PRODUCT / PROCESS CHANGE NOTIFICATION	
---------------------------------------	--

1.1 Company		STMicroelectronics International N.V
1.2 PCN No.		MDG/22/13615
1.3 Title of PCN		ASE Kaohsiung (Taiwan) additional source for UQFPN 5x5 32L and UQFPN 7x7 48L package - on listed products
1.4 Product Category		STM32C0x STM32G0x STM32G4x STM32L4x STM32U0x
1.5 Issue date		2022-09-21

**ASE Kaohsiung (Taiwan) additional source for UQFPN 5x5 32L
and UQFPN 7x7 48L package - on listed of products**

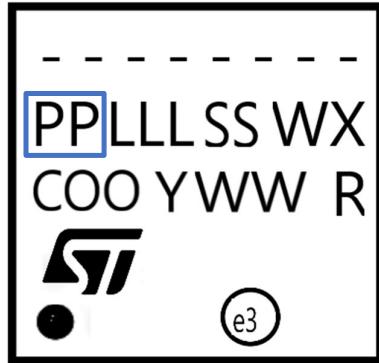
(1) Package darkness changes depending on molding compound.

Pin1 identifier can change in terms of form and positioning.

Marking position and size could be different upon assembly site, without any loss of information.
